**CITY OF MADISON HEIGHTS
ELECTRONIC COUNCIL AGENDA REQUEST FORM**

Special approval request PSP 22-07 - Hudson Madison II LLC/Reserve at Red Run Phase II - 30151, 30171 and 30183 Dequindre Rd. - Rest/Convalescent Home

Date: June 30th, 2022
To: City of Madison Heights City Council
From: Matt Lonnerstater, AICP – City Planner
Subject: Special Approval Request PSP 22-07 – 30171 Dequindre – ‘Reserve at Red Run Phase II’

DRAWING TITLE:
PRELIMINARY SITE PLAN

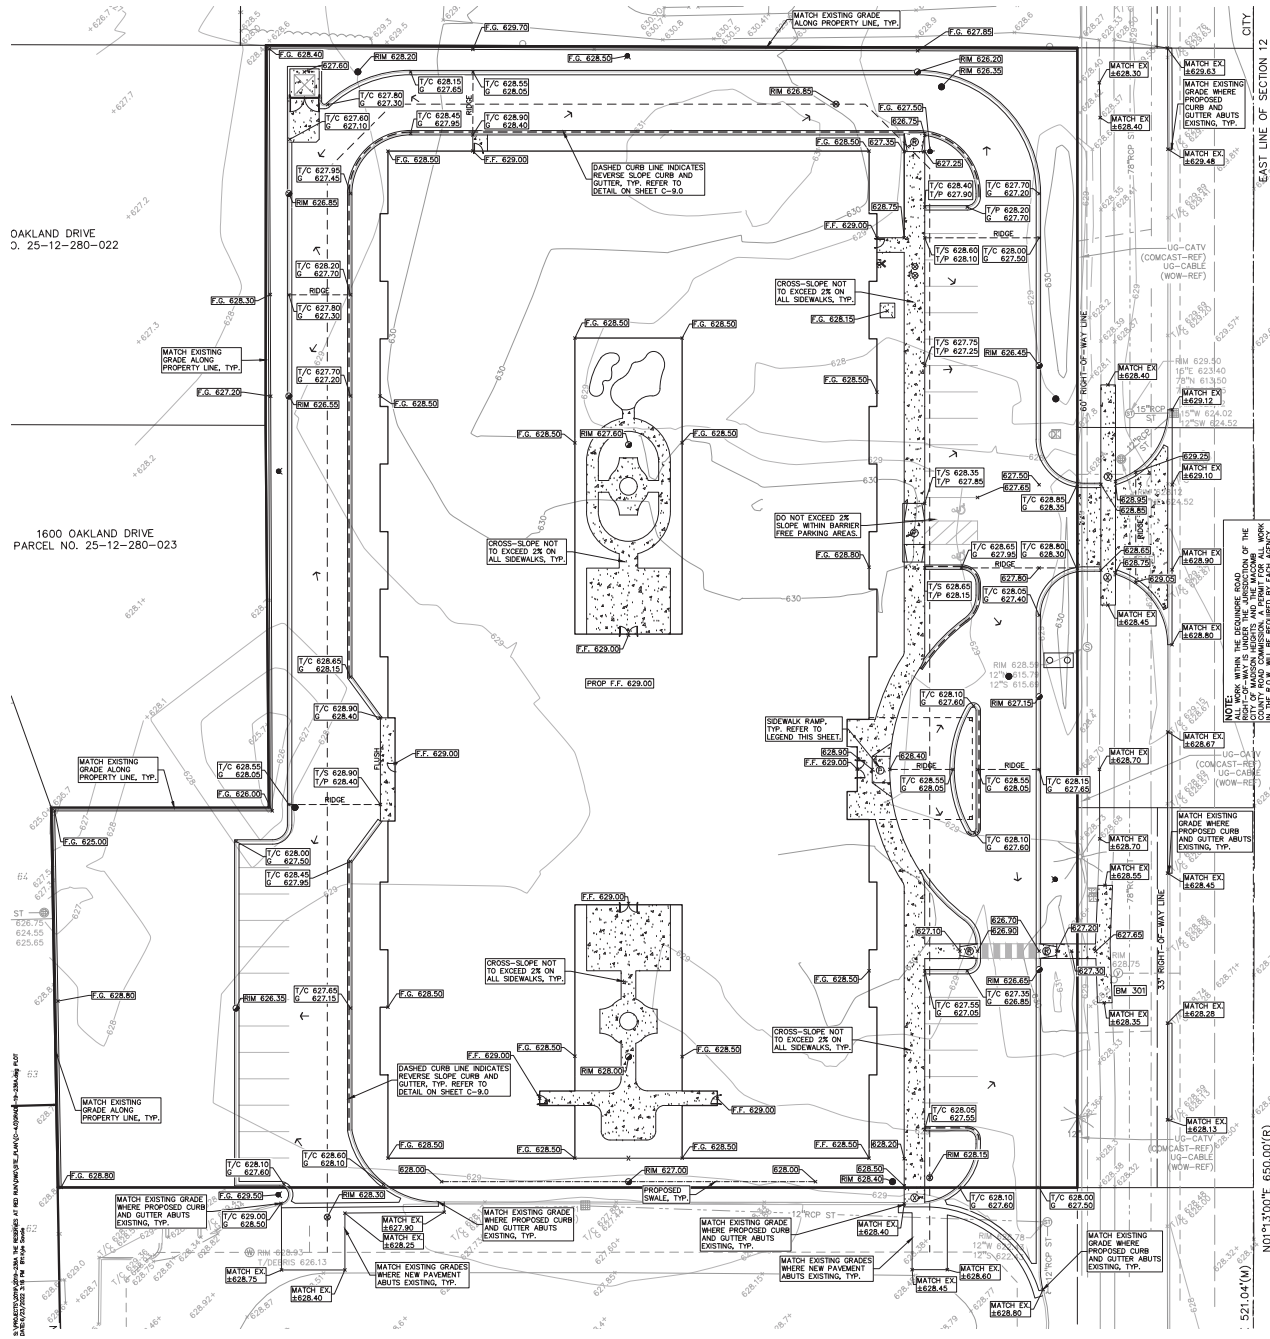
Section **10.312(1)** of the Zoning Ordinance contains use-specific standards for rest or convalescent homes in the R-M zoning district. Based on the proposed concept plan, the project fails to satisfy the following standard:

No building is closer than 25 feet to any lot line.

As proposed, the one-story building is set back 10 feet from the southern property line. Further, the proposed building exceeds the maximum 35% lot coverage standard permitted for the R-M zoning district (42.6% lot coverage proposed). The applicant will need to modify the site plan to meet these standards or request variances from the Zoning Board of Appeals for these deficient items.

- If City Council **approves** the concurrent rezoning to R-M under PRZN 22-01, staff recommends City Council **approve** the requested special use with the following conditions:
 1. Resolve site plan deficiencies relating to the southern building setback and maximum lot coverage **or** seek the appropriate variances from the Zoning Board of Appeals.
 2. Upon Site Plan submittal, provide a revised Landscape Plan that depicts a greater number of evergreen and deciduous trees at the southwest corner of the site. The revised Landscape Plan should result in a denser, continuous landscape buffer and shall be provided to the satisfaction of the Site Plan Review Committee (SPRC).
